SB-57

Multiplex System Programming Update, 2018 Allegro Buses and Phaetons

January 25, 2018

Picture 1-B

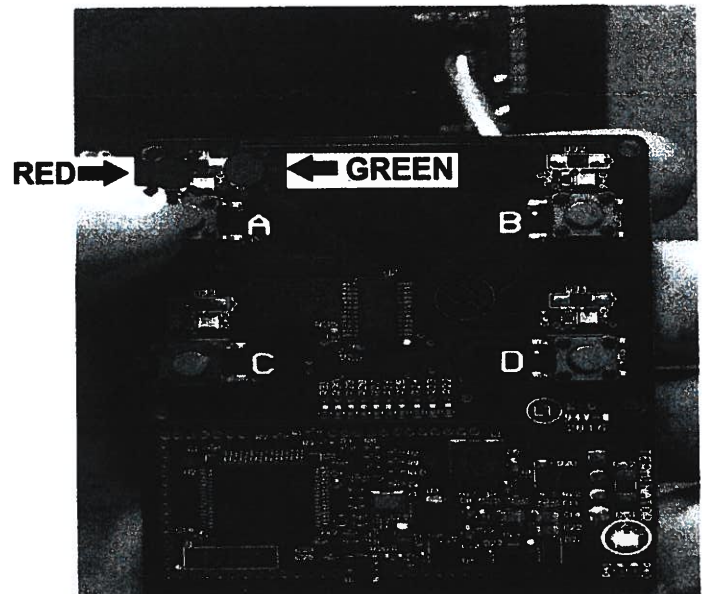
2. Once you plug the Programmer Switch Panel in the NET PORT on the front of the G6 Panel, you should see a bright LED light turn on solid GREEN. This indicates that your Programmer Switch Panel is on and functioning properly. Once you have verified this, you will notice that there are 4 buttons labeled as A - D. For this application, you will want to press Button A only. When you press Button A, you should see the LED flash RED/GREEN. This indicates that the update is in progress. (Often times, the update is performed so quickly that you do not see the RED LED color.)

When "Button A" LED turns solid GREEN, this indicates that the programming is successful and you can now unplug the Programmer Switch Panel from the NET PORT. Refer to Picture 1-B for "Button A" location.
